## PIC16C76 Rev. A Silicon Errata Sheet

The PIC16C76 (Rev. A) parts you have received conform functionally to the Device Data Sheet (DS30390E), except for the anomalies described below.

In the Device Data Sheet (DS30390E), the following clarifications and corrections should be noted.

**FIGURE 1: WRITES TO TIMER1 (EXTERNAL CLOCK/OSCILLATOR MODE)**

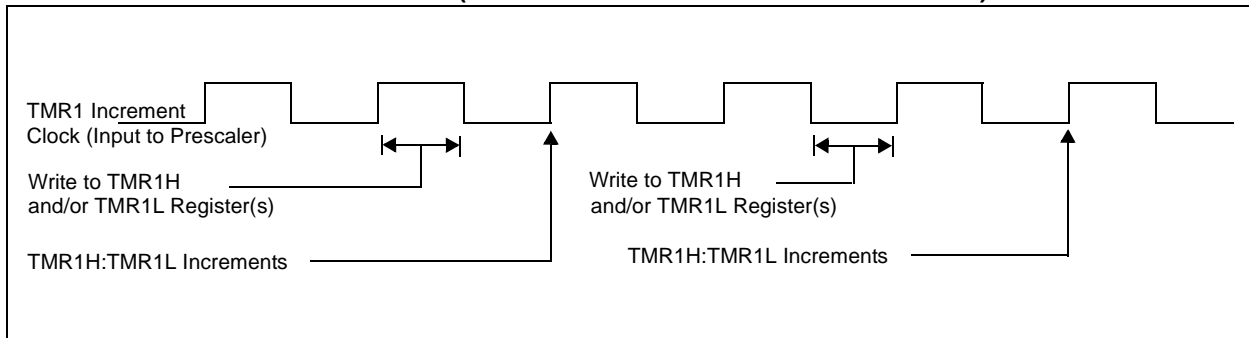
The operation of Timer1 needs some clarification when the timer registers are written when the TMR1ON bit is set.

The internal clock signal that is the input to the TMR1 prescaler affects the incrementing of Timer1 (TMR1H:TMR1L registers and the Timer1 prescaler). When the Timer1 registers are NOT written, the Timer1 will increment on the rising edge of the TMR1 increment clock.

When the TMR1H and/or TMR1L registers are written while this clock is high, TMR1 will increment on the next rising edge of this clock.

When the TMR1H and/or TMR1L registers are written while this clock is low, TMR1 will not increment on the next rising edge of this clock, but must first have a falling clock and the rising clock, for TMR1 to increment.

Figure 1 shows the two cases of writes to the TMR1H and/or TMR1L registers. Due to the V<sub>IH</sub> and V<sub>IL</sub> thresholds on the oscillator/clock pins, external Timer1 oscillator components, and external clock frequency, the Timer1 increment clock may not be of a 50% duty cycle.

The TMR1 increment clock is out of phase of the T1OSO/T1CKI pin by a small propagation delay.
